Richland County School District One
Invitation for Bids: Meadowfield Elementary School Parking Lot Addition

Richland County School District One INVITATION FOR BIDS FOR CONSTRUCTION SERVICE AMENDMENT No. 1	Solicitation # Date Issued Procurement Officer Phone E-mail Address	2026-010 JUNE 22, 2026 Brittany Green 803.231.7052 brittany.green@richlandone.org
--	---	--	--

Solicitation No. 2026-010
Meadowfield Elementary School Parking Addition
Amendment No. 1

THIS AMENDMENT IS TO ANSWER QUESTIONS FROM OFFERORS.

Drawn: EYC
Checked: GAL
Revised: 07/22/2025 Revised per SCDOT's comments
04/15/2026 Revised per SCDOT's comments
Project No.: 398720C
File: 398720C-25.dwg

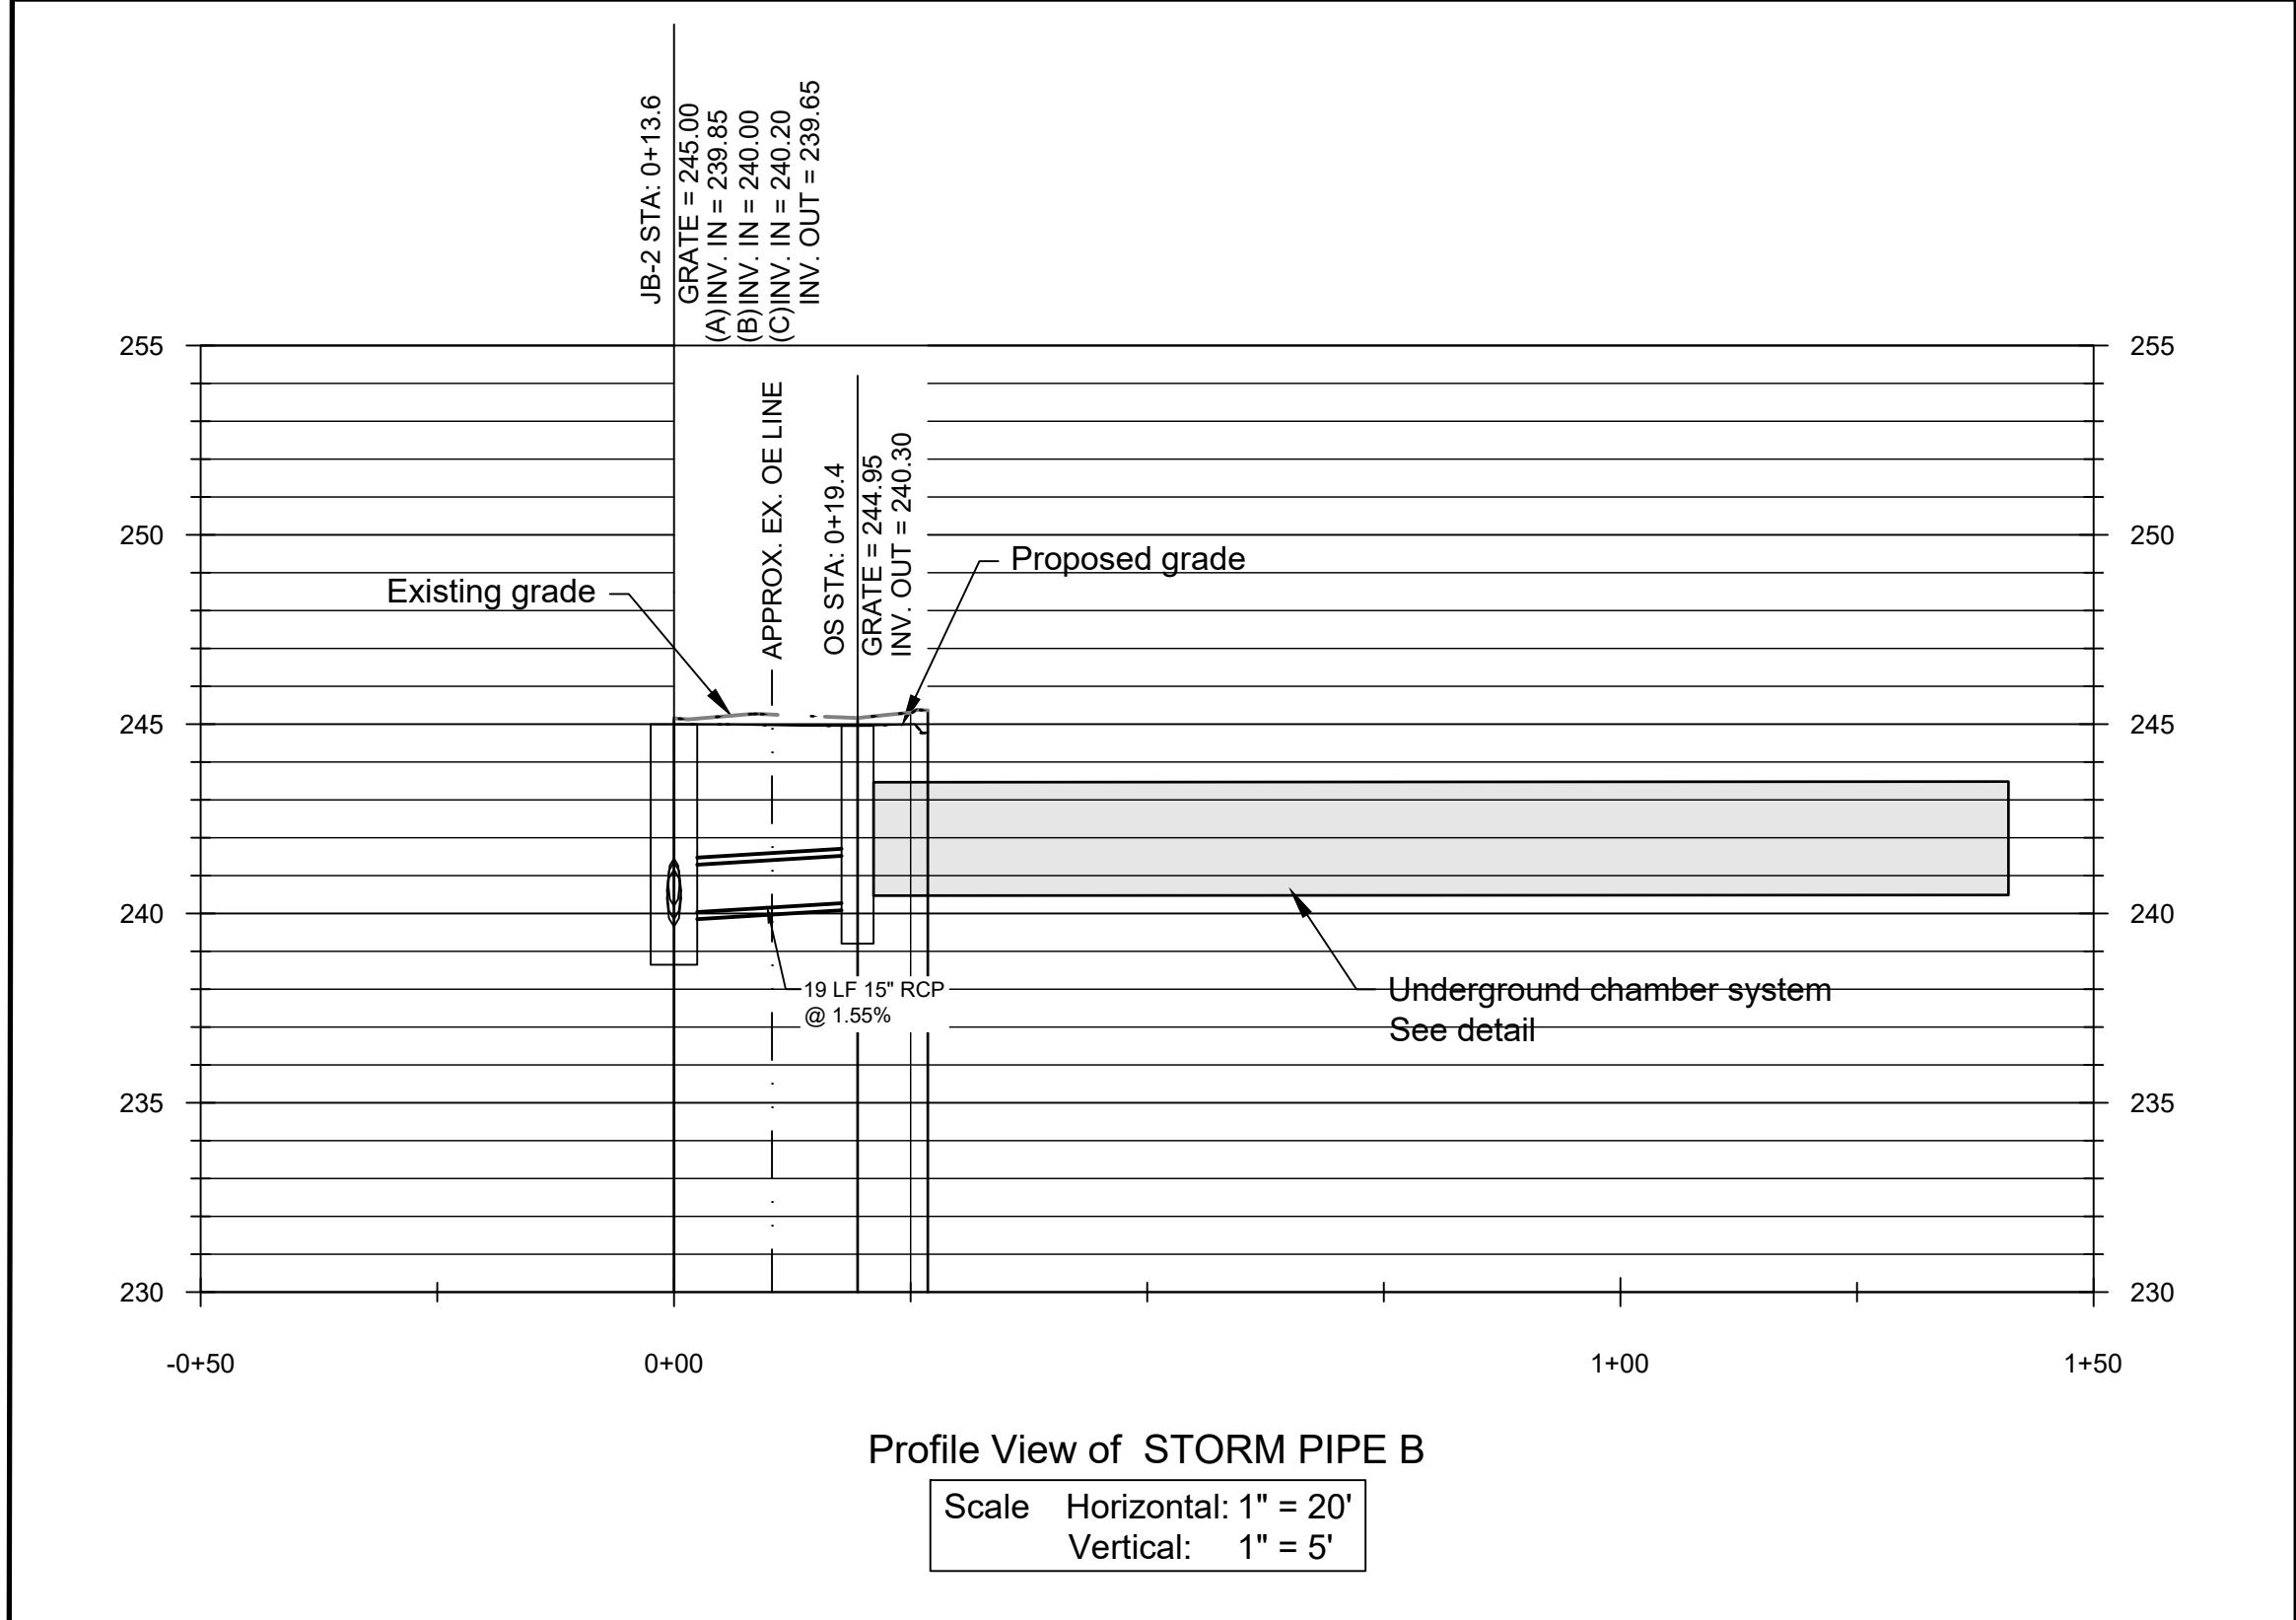
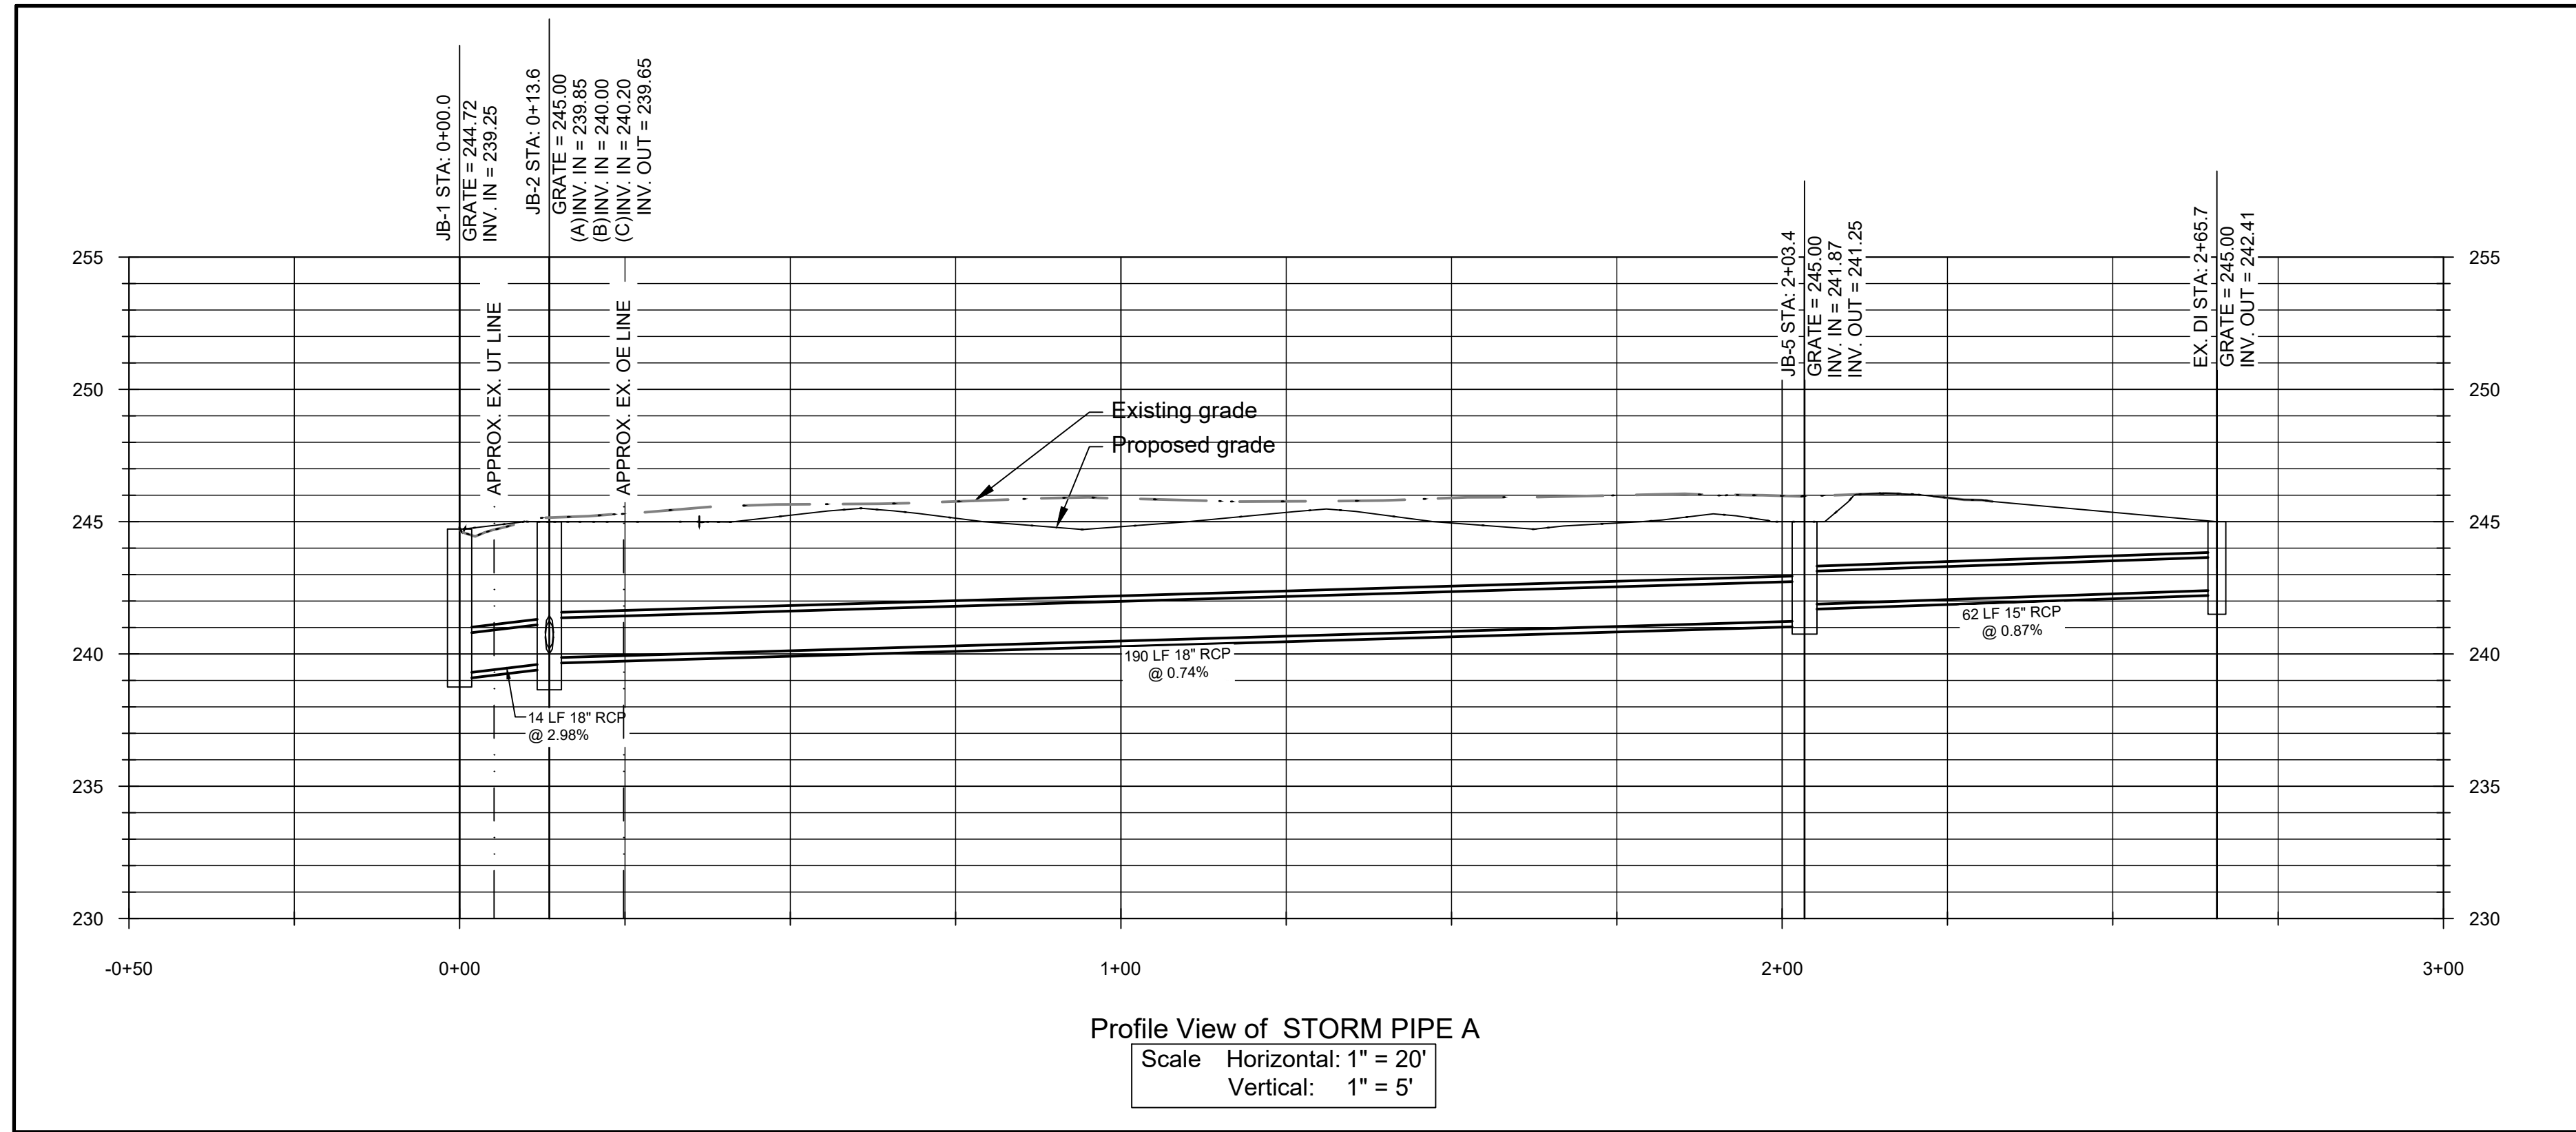
Q8: Sheet C3.0 shows the contractor is to install a type 16 out by Galway Lane but shows the structure as existing on C1.0. I did not see an existing structure on the site. So is the contractor to install a complete Type 16 (doghouse) in this area?

A8: Yes, a new Type 16 doghouse will be required.
